Application for Variation of an Environmental Permit

C2. Application No. of the Current Environmental Permit : AEP-532/2017

Project:  
 Mui Wo Lai Chi Yuen Extension

**ENVIRONMENTAL REVIEW  
REPORT**

Drawing Title:  
Layout Plan of EIA Scheme

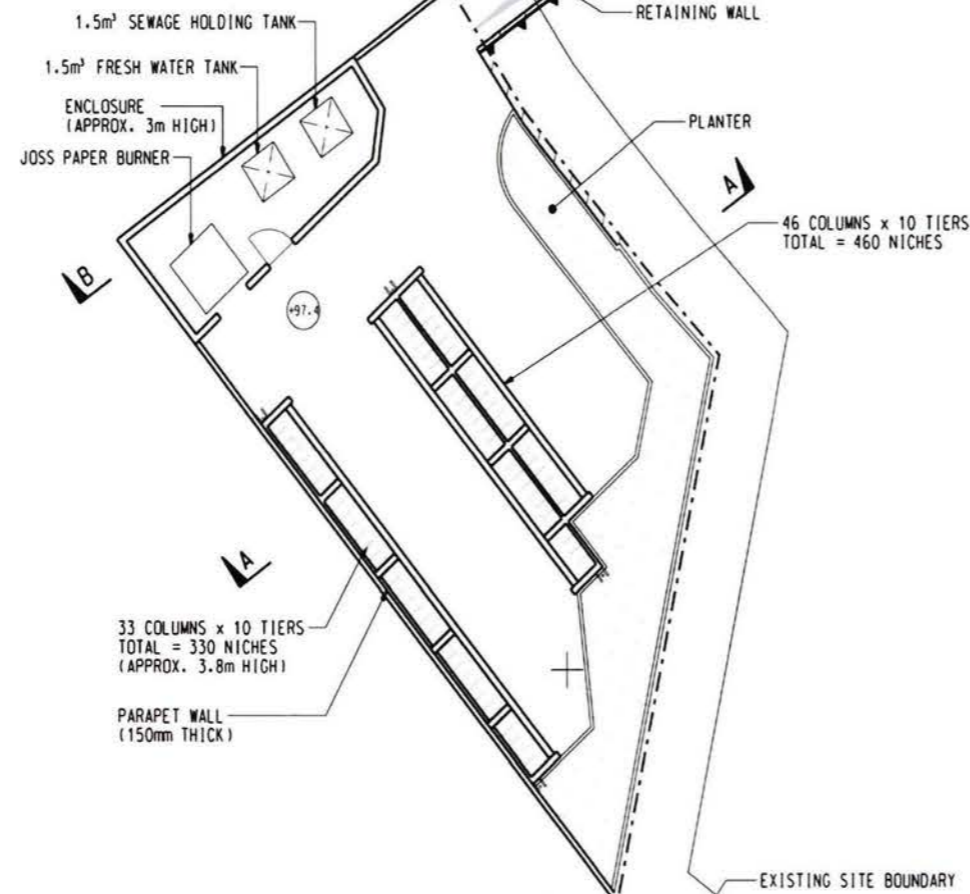
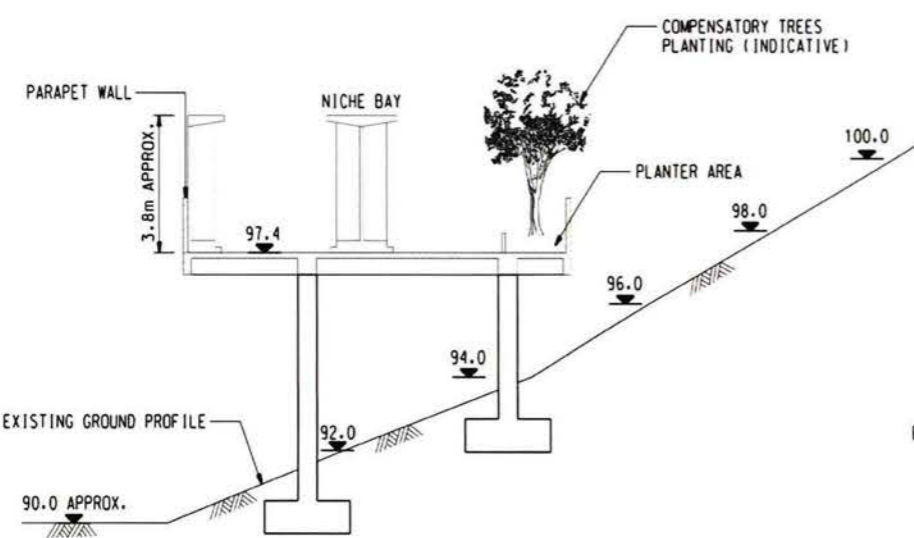
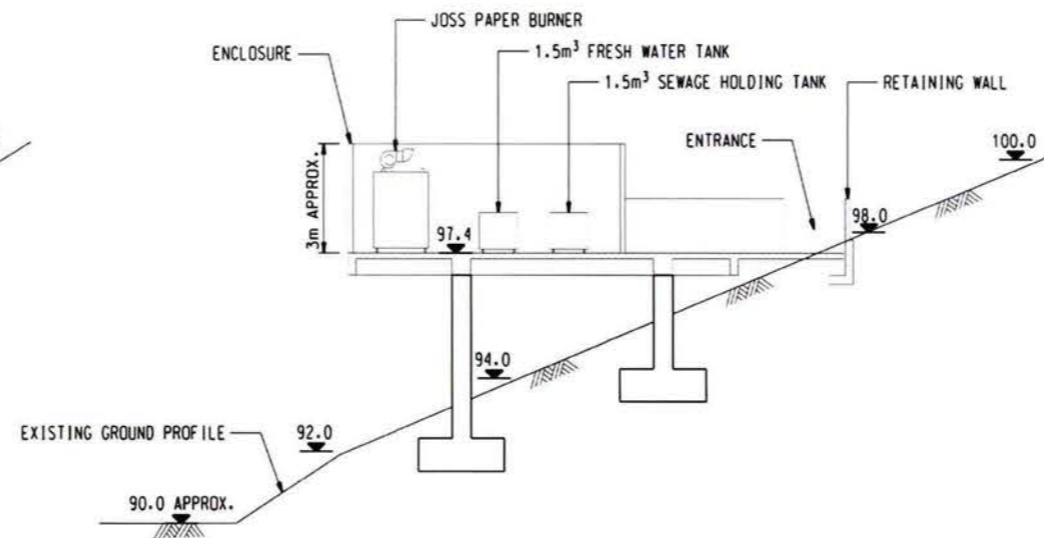
2.1.2 In the original design presented in the approved EIA report (hereafter named as “the EIA Scheme”), a single-layer elevated platform of around 225m<sup>2</sup> supported by structural columns will be constructed to accommodate some 790 niches facing north-east or south-west. A site access of 7.5m<sup>2</sup> will also be constructed just outside the cemetery boundary to connect the platform with the existing cemetery.

2.2.3 A comparison of the design parameters for the Proposed Scheme for this ER and the EIA Scheme is outlined in *Table 2-1* below. The layout plan of the EIA Scheme and proposed Scheme are shown in *Figures 2-2* and *2-3* respectively.

Layout Plan of Proposed Scheme

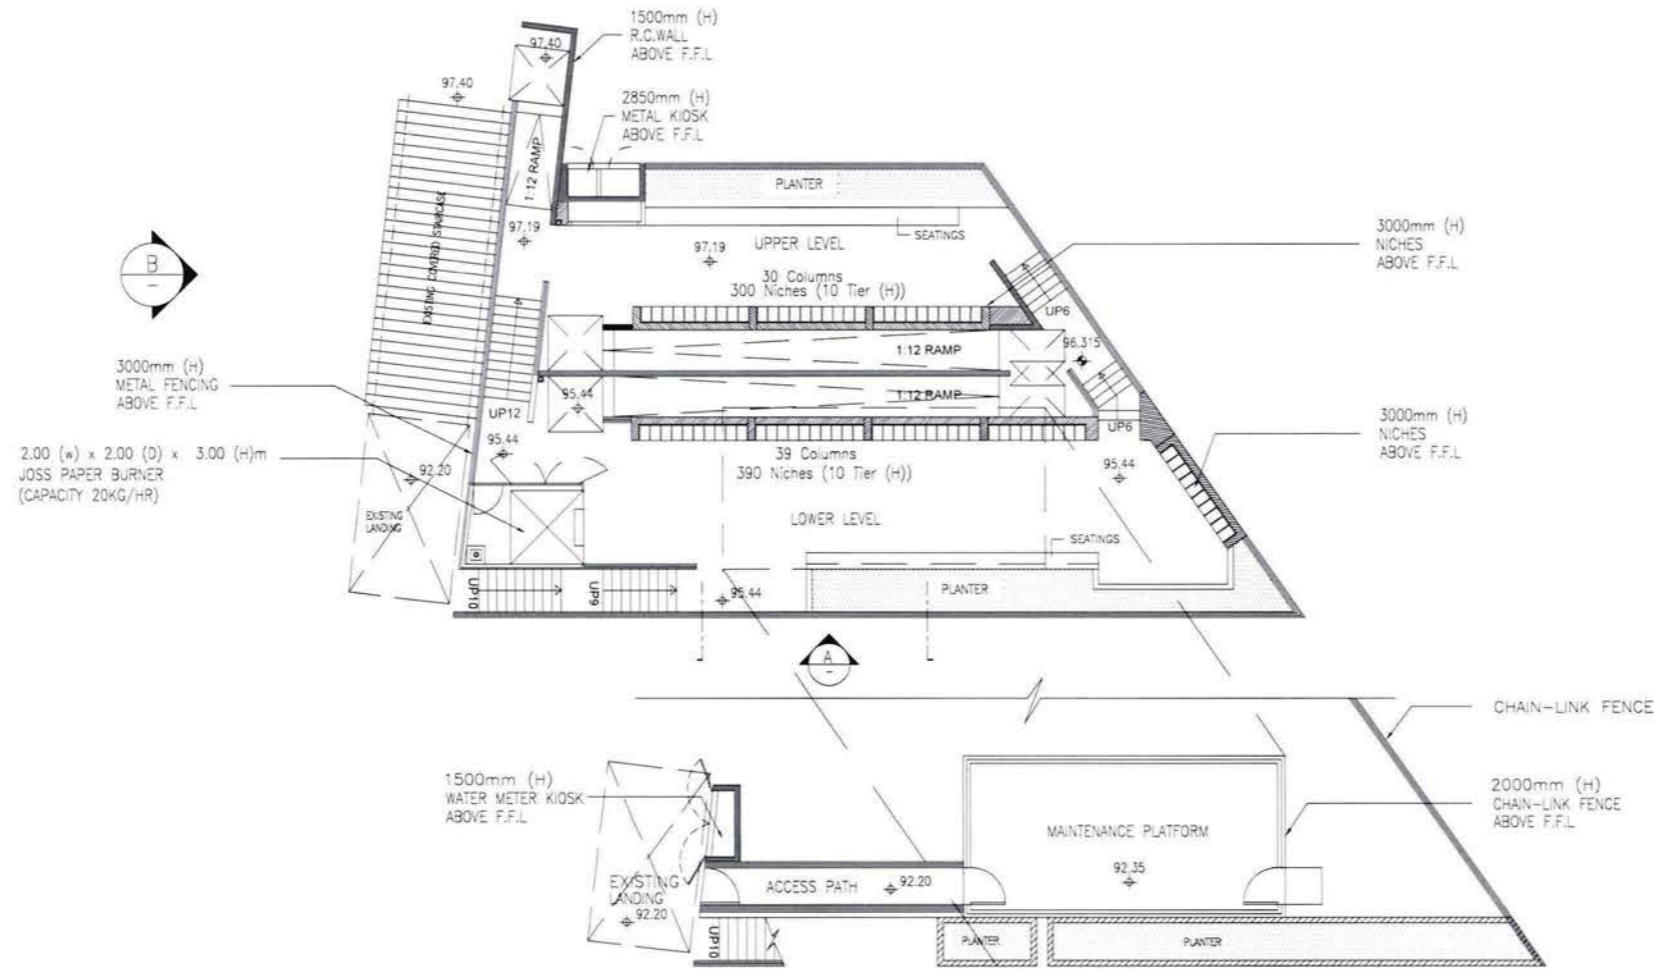
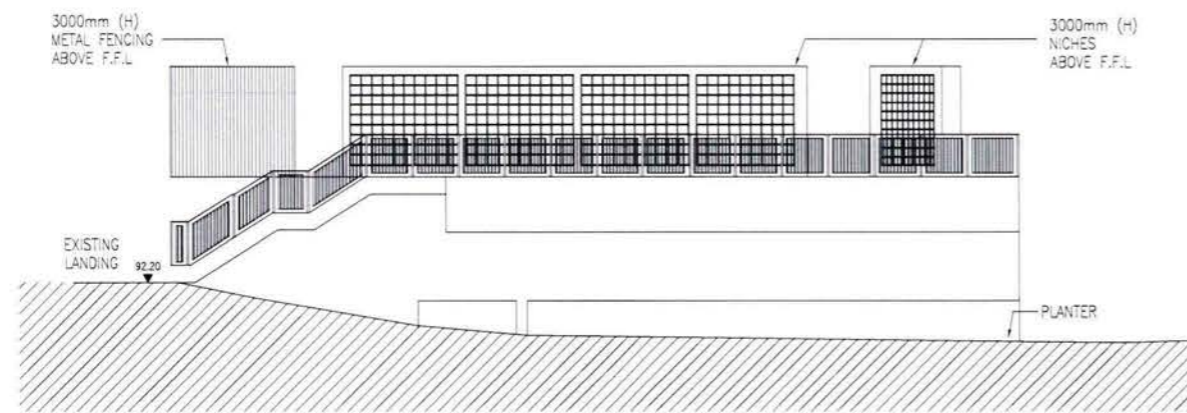
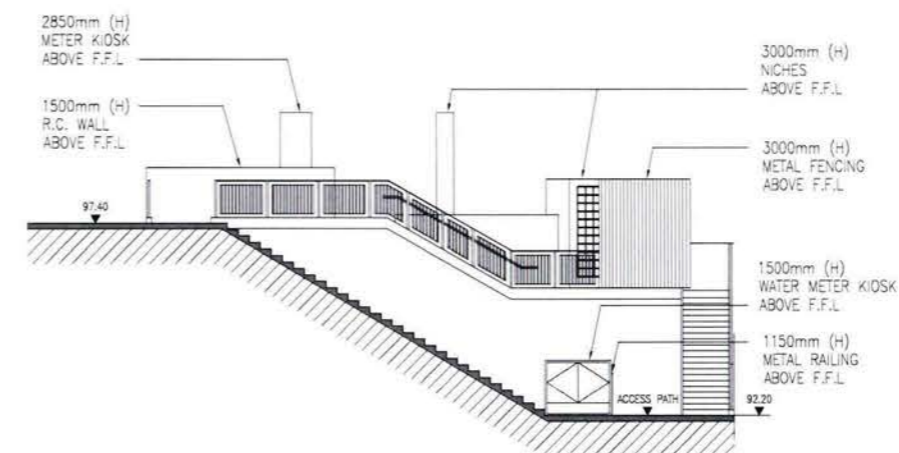
2.2.1 The proposed update design of the Project (hereafter named as “the Proposed Scheme”) has largely followed the EIA Scheme. With the site boundary and footprint of the platform remain unchanged, the following slight modifications to the layout design are made:

- a) Adoption of split-level design for the platform;
- b) The water pumps will be installed on the maintenance platform located at mezzanine floor underneath the platform;
- c) Orientation of the niches is reference to the existing graves and face north east, south-west and west.

Drawing Title: On-site Landscape and Visual Mitigation Measures of Proposed Scheme

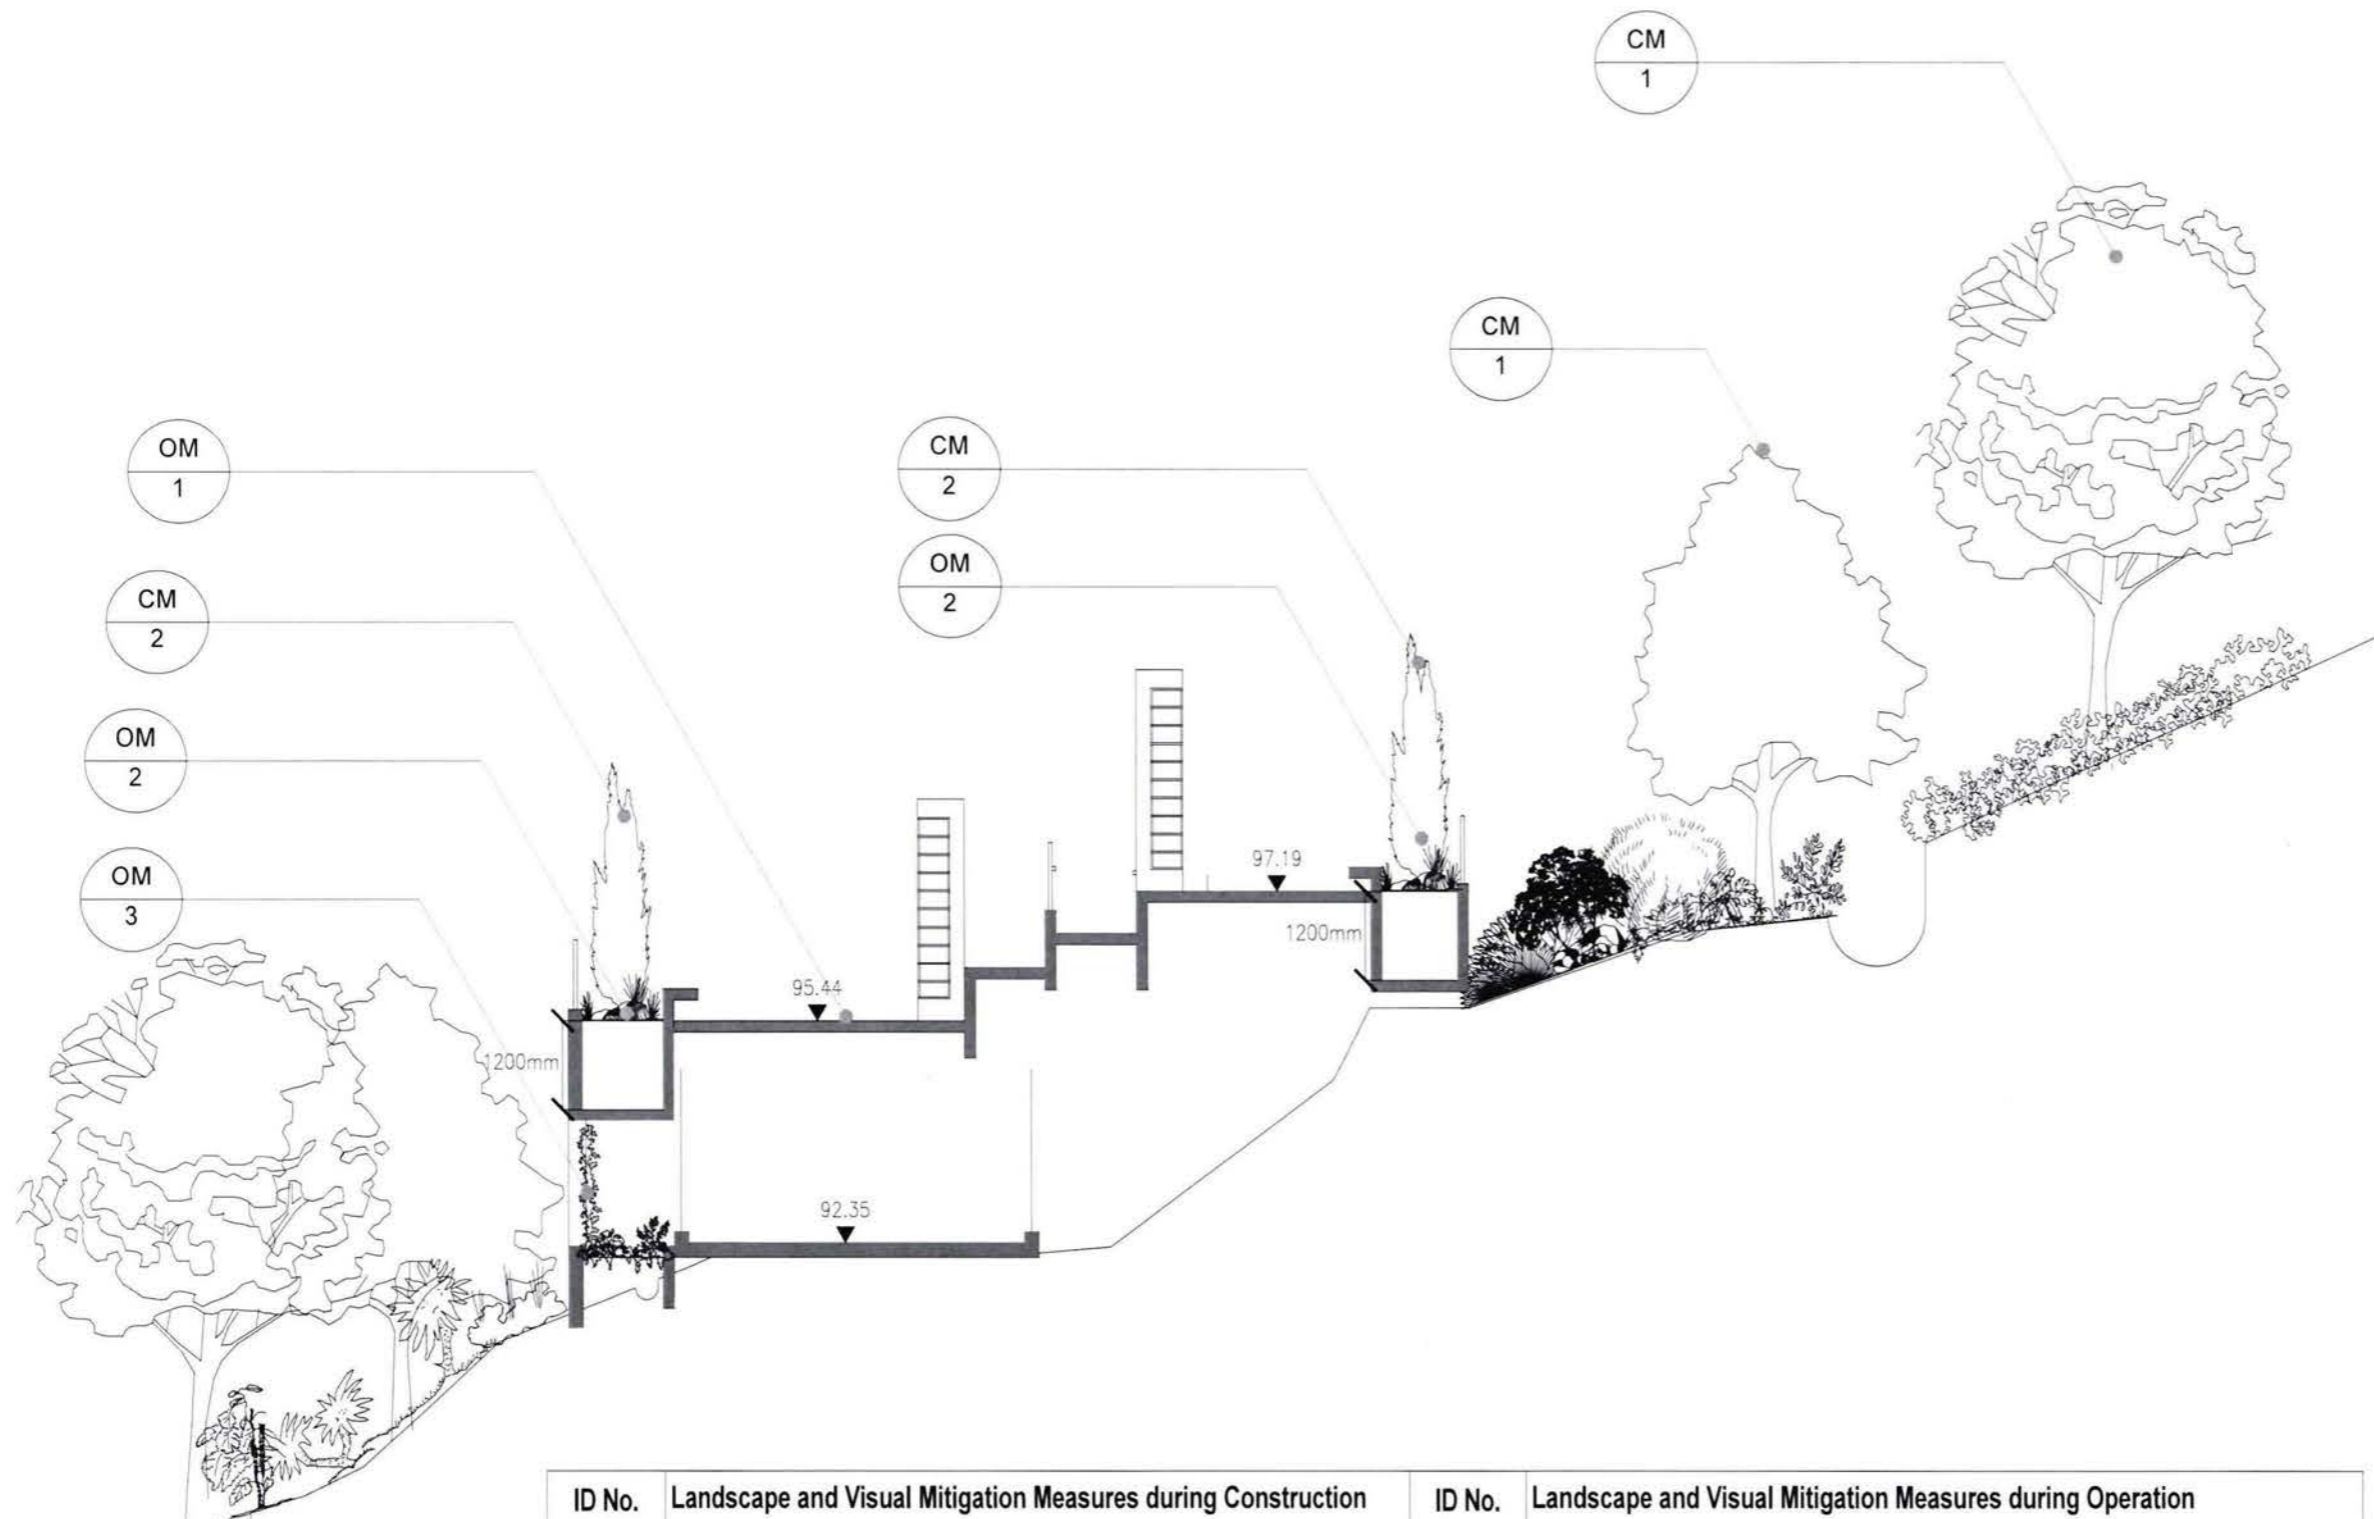
11) With the implementation of mitigation measures, which include aesthetically pleasing design of above ground structures, amenity tree and shrub planting and screen planting to soften the structural columns of the elevated platform, it is predicted that the residual visual impact on the visitors to Lai Chi Yuen Cemetery would remain slight in day 1 and year 10 of the operation. Photomontages of the EIA Scheme are extracted from Figure 9.5 of the EIA report and presented in <i>Figure 3-3</i> .	11) Mitigation measures, including aesthetically pleasing design of above ground structures, amenity tree and shrub planting and screen planting to soften the concrete structure of the elevated platform, will continue to be provided in the Proposed Scheme. It is predicted that the residual visual impact on the visitors to Lai Chi Yuen Cemetery would remain slight in day 1 and year 10 of the operation. Photomontages of the Proposed Scheme are presented in <i>Figure 3-4</i> .
